Service Bulletin No: 34-010

Modification No: EC-21-0263, EC-22-0449

**NAVIGATION - WEATHER RADAR SYSTEM
REDUNDANT WEATHER RADAR WIRING MODIFICATION****1. Planning information****A. Effectivity**

Part 2 - Wiring Diagram 34-49-90 - Weather Radar (RDR-7000) (Pre Service Bulletin)
 Figure 3 (Sheet 1 of 4)

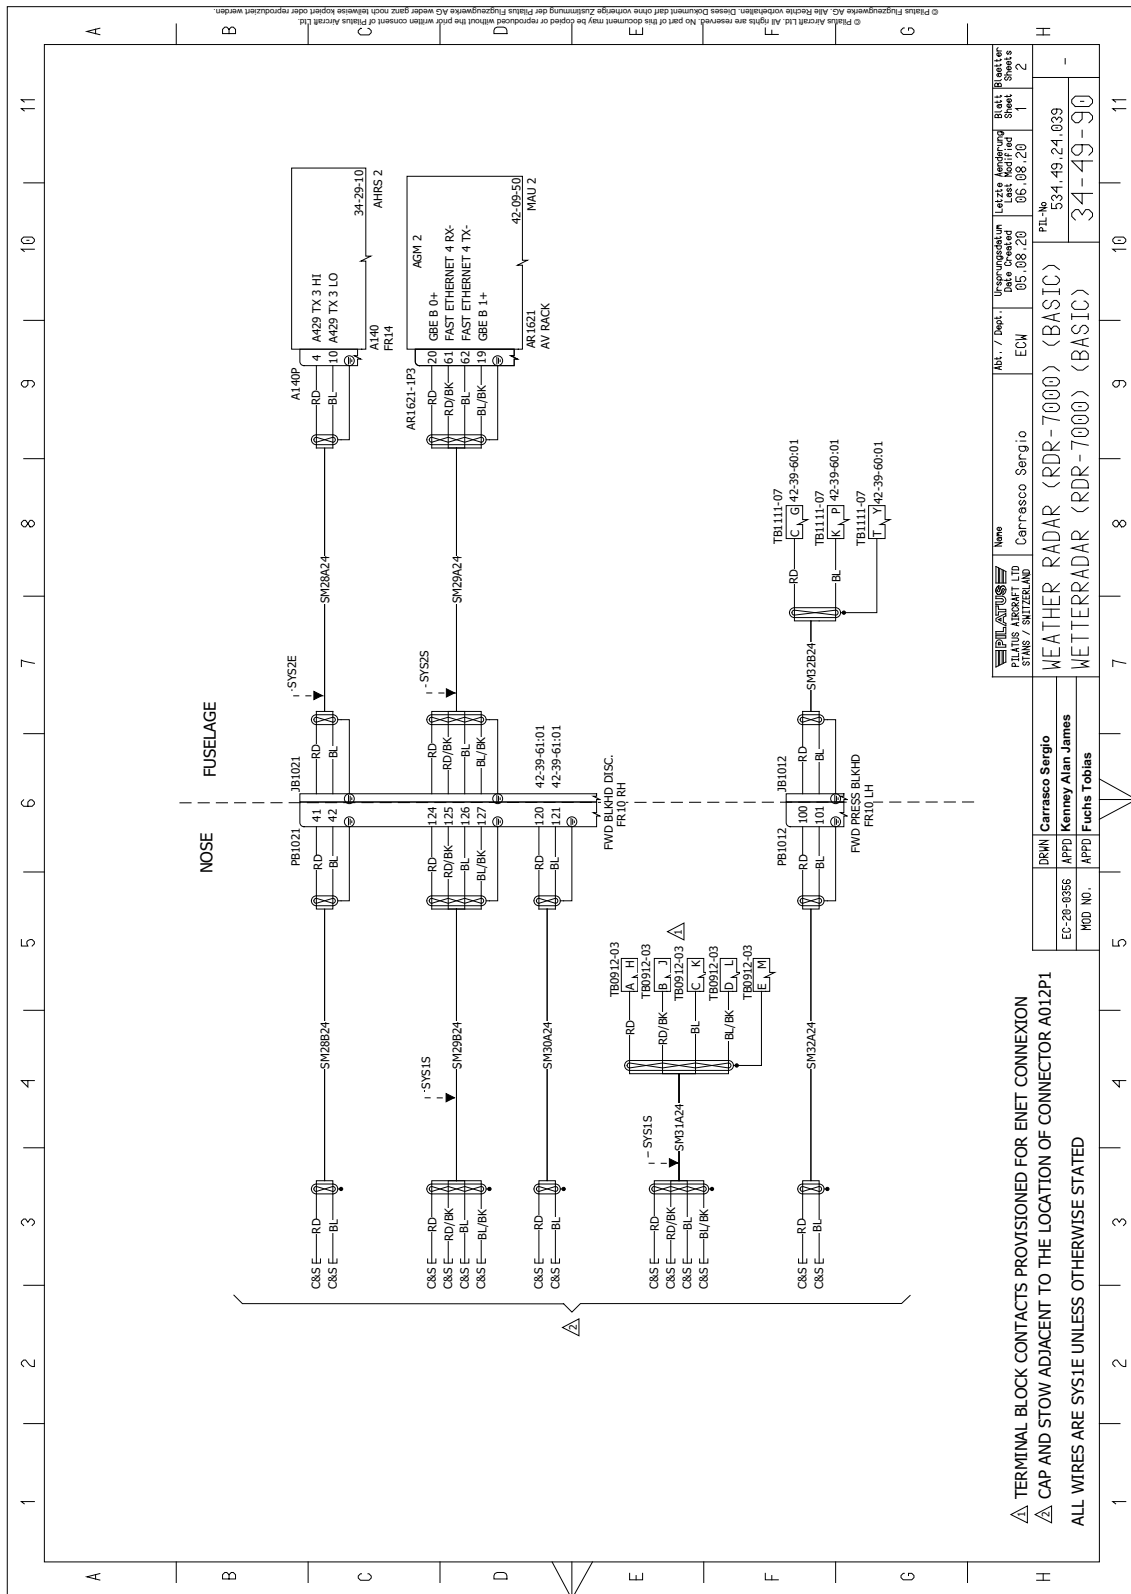
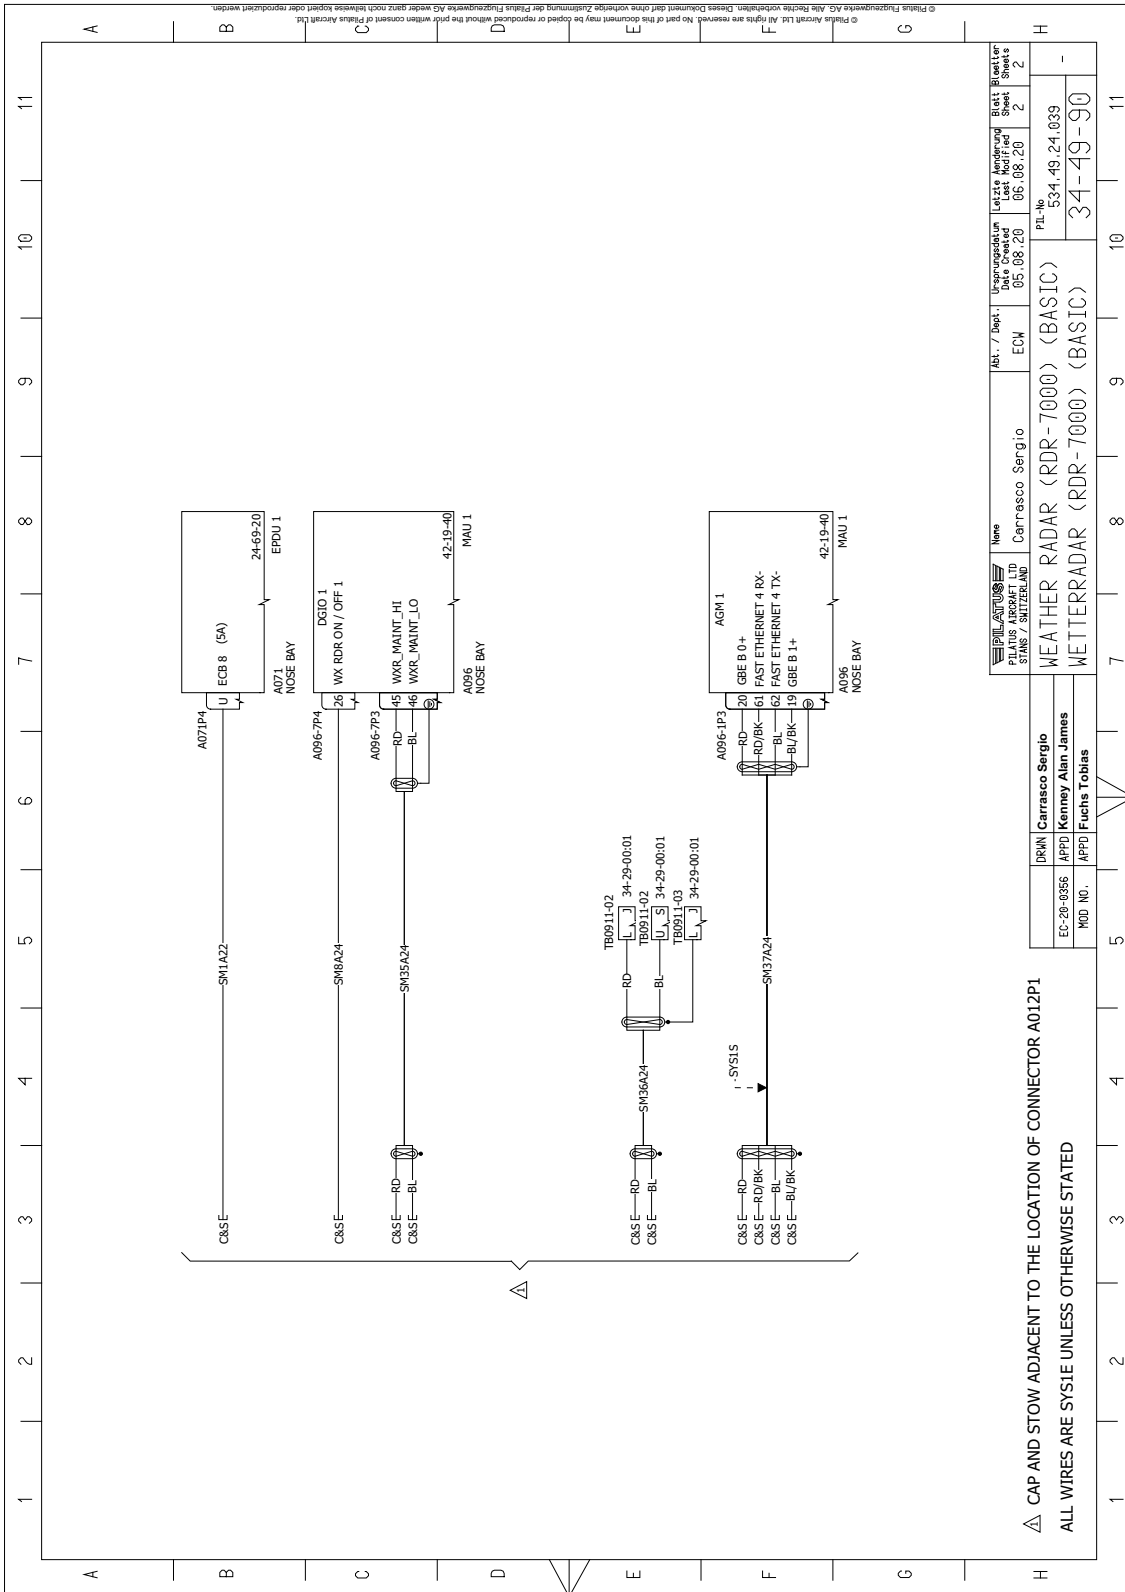
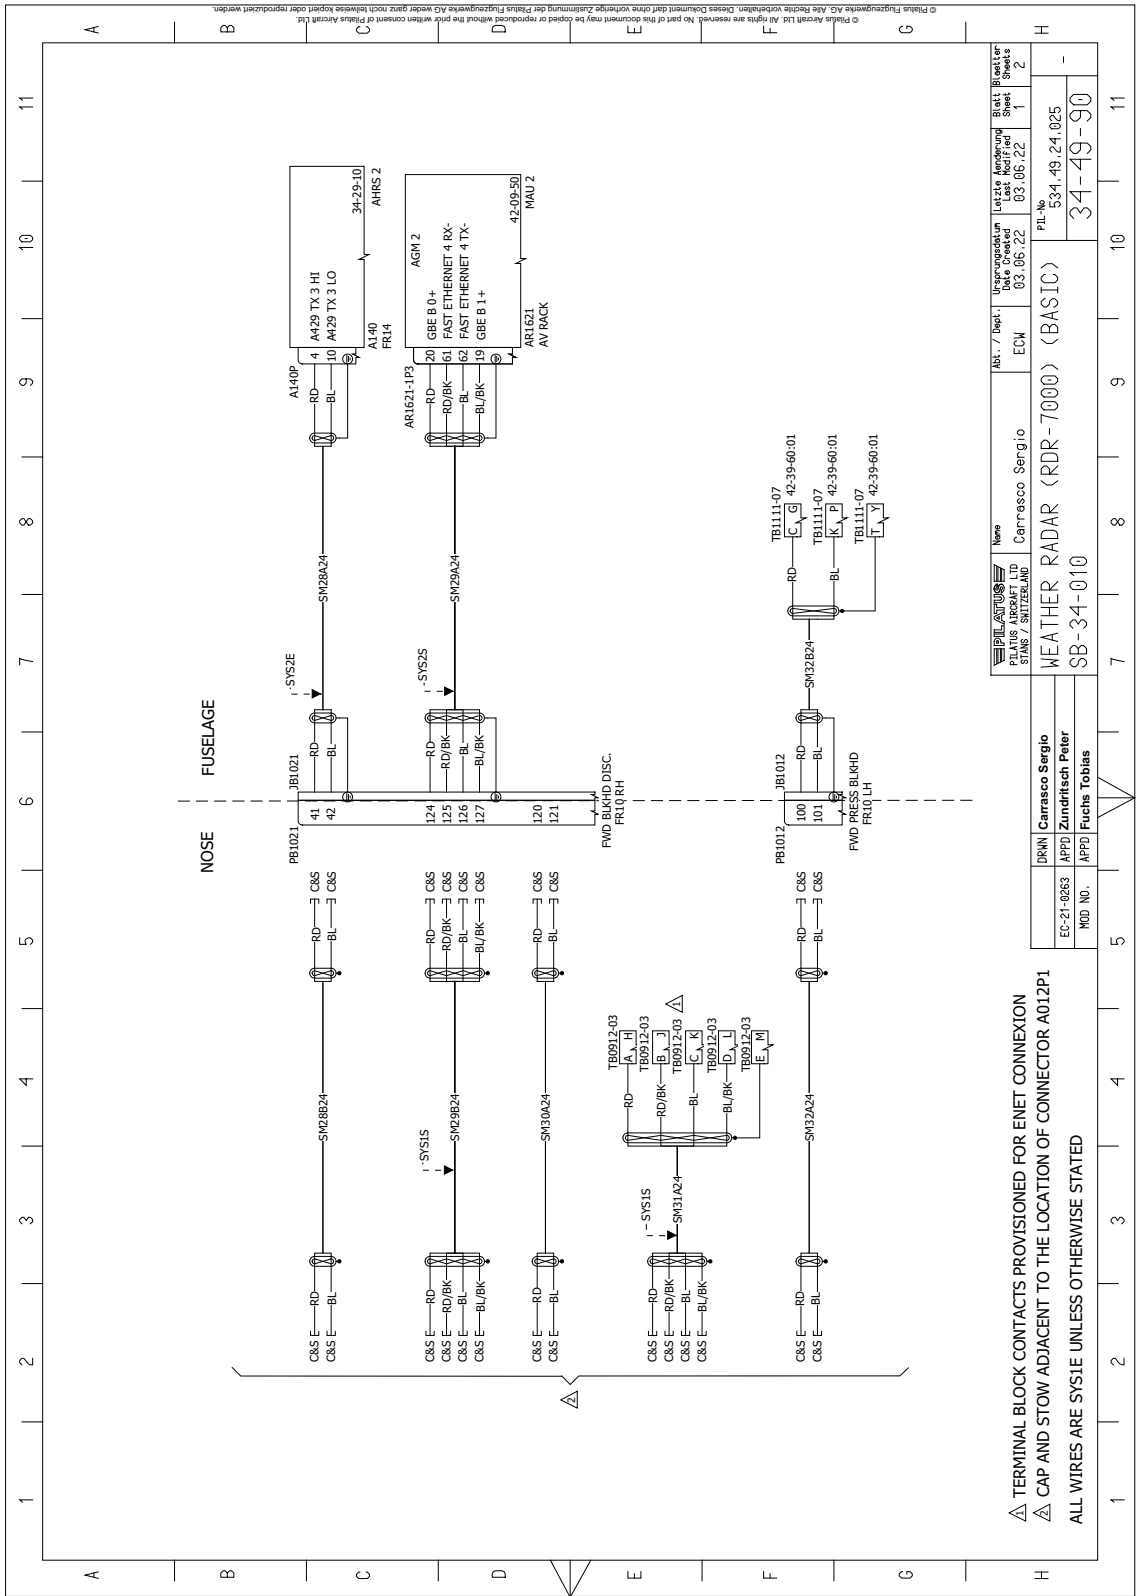
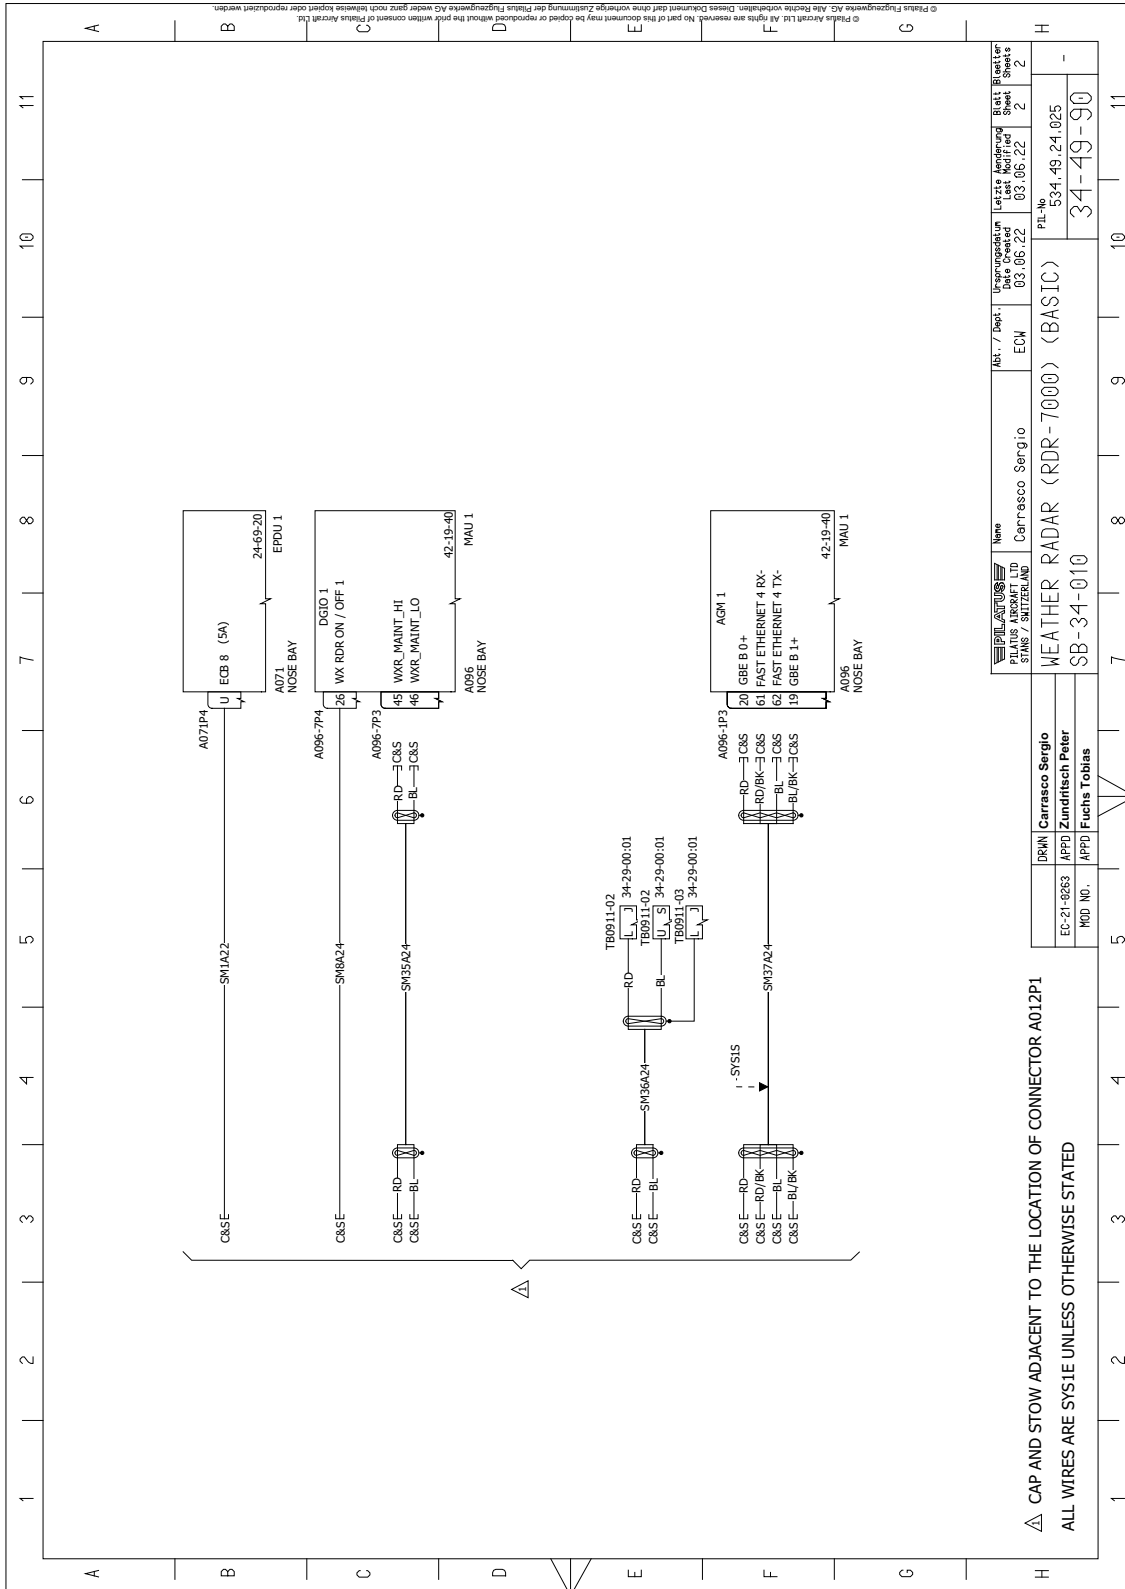
- (3) Use the applicable insert/extract tool and disconnect the wires from the electrical connector PB1021. Refer to Figure 3, and Figure 4 - Hook-Up Chart 2 (Line 1 thru 11):

- (a) Disconnect the red wire of cable SM28B24 from terminal 41 of the electrical connector PB1021.
 - (b) Disconnect the blue wire of cable SM28B24 from terminal 42 of the electrical connector PB1021.

- (c) Remove (and discard) the band clamp and disconnect the cable shield of cable SM28B24 from the backshell of the electrical connector PB1021.
 - (d) Disconnect the red wire of cable SM29B24 from terminal 124 of the electrical connector PB1021.

- (e) Disconnect the red/black wire of cable SM29B24 from terminal 125 of the electrical connector PB1021.
 - (f) Disconnect the blue wire of cable SM29B24 from terminal 126 of the electrical connector PB1021.

- (g) Disconnect the blue/black wire of cable SM29B24 from terminal 127 of the electrical connector PB1021.
 - (h) Remove the cable shield of cable SM29B24 from the backshell of the electrical connector PB1021.

- (i) Disconnect the red wire of cable SM30A24 from terminal 120 of the electrical connector PB1021.
 - (j) Disconnect the blue wire of cable SM30A24 from terminal 121 of the electrical connector PB1021.

- (k) Remove the cable shield of cable SM30A24 from the backshell of the electrical connector PB1021.

- (4) Use the applicable insert/extract tool and disconnect the wires from the electrical connector PB1012. Refer to Figure 3, and Figure 4 - Hook-Up Chart 2 (Line 12 thru 14):

- (a) Disconnect the red wire of cable SM32A24 from terminal 100 of the electrical connector PB1012.
 - (b) Disconnect the blue wire of cable SM32A24 from terminal 101 of the electrical connector PB1012.

- (c) Remove (and discard) the band clamp and disconnect the cable shield of cable SM32A24 from the backshell of the electrical connector PB1012.
 - (d) Install a new contact (P/N 971.75.17.911) and a seal plug (filler pin) (P/N 971.75.18.921) in each of the terminals where you disconnected the wires.

- (5) Use the applicable insert/extract tool and disconnect the wires from the electrical connector A096-7P3. Refer to Figure 3, and Figure 4 - Hook-Up Chart 2 (Line 15 thru 17):

- (a) Disconnect the red wire of cable SM35A24 from terminal 45 of the electrical connector A096-7P3.
 - (b) Disconnect the blue wire of cable SM35A24 from terminal 46 of the electrical connector A096-7P3.

- (6) Use the applicable insert/extract tool and disconnect the wires from the electrical connector A096-1P3. Refer to Figure 3, and Figure 4 - Hook-Up Chart 2 (Line 18 thru 22):

- (a) Disconnect the red wire of cable SM37A24 from terminal 20 of the electrical connector A096-1P3.
 - (b) Disconnect the red/black wire of cable SM37A24 from terminal 61 of the electrical connector A096-1P3.

- (c) Disconnect the blue wire of cable SM37A24 from terminal 62 of the electrical connector A096-1P3.
 - (d) Disconnect the blue/black wire of cable SM37A24 from terminal 19 of the electrical connector A096-1P3.

- (e) Disconnect the cable shield of cable SM37A24 from the backshell of the electrical connector A096-1P3.
 - (f) Install a blind contact (P/N 971.75.16.829) in each of the terminals where you disconnected the wires.

- (l) Install a new contact (P/N 971.75.17.911) and a seal plug (filler pin) (P/N 971.75.18.921) in each of the terminals where you disconnected the wires.
- (m) Use a new band clamp (P/N 971.32.51.210) and connect all of the remaining cable shield(s)/shield wire(s) to the backshell of the electrical connector PB1021.
- (n) Connect the backshell to the electrical connector PB1021.
- (o) Cap the wires that you disconnected and stow them on the wiring harness near the electrical connector PB1021.

- (e) Use a new band clamp (P/N 971.32.51.210) and connect all of the remaining cable shield(s)/shield wire(s) to the backshell of the electrical connector PB1012.

- (f) Connect the backshell to the electrical connector PB1012.
 - (g) Cap the wires that you disconnected and stow them on the wiring harness near the electrical connector PB1012.

- (c) Disconnect the cable shield of cable SM35A24 from the backshell of the electrical connector A096-7P3.
 - (d) Install a blind contact (P/N 971.75.16.829) in each of the terminals where you disconnected the wires.

- (e) Close the backshell of the electrical connector A096-7P3.
 - (f) Cap the wires that you disconnected and stow them on the wiring harness near the electrical connector A096-7P3.

- (g) Install a dummy ferrule (P/N 971.19.26.111) in the empty hole in the backshell of the electrical connector A096-1P3.
 - (h) Close the backshell of the electrical connector A096-1P3.

- (i) Cap the wires that you disconnected and stow them on the wiring harness near the electrical connector A096-1P3.
 - 1 Use shrink Hose P/N 917.99.88.605 to isolate the shield. Do not use shrink hose P/N 917.99.88.604.
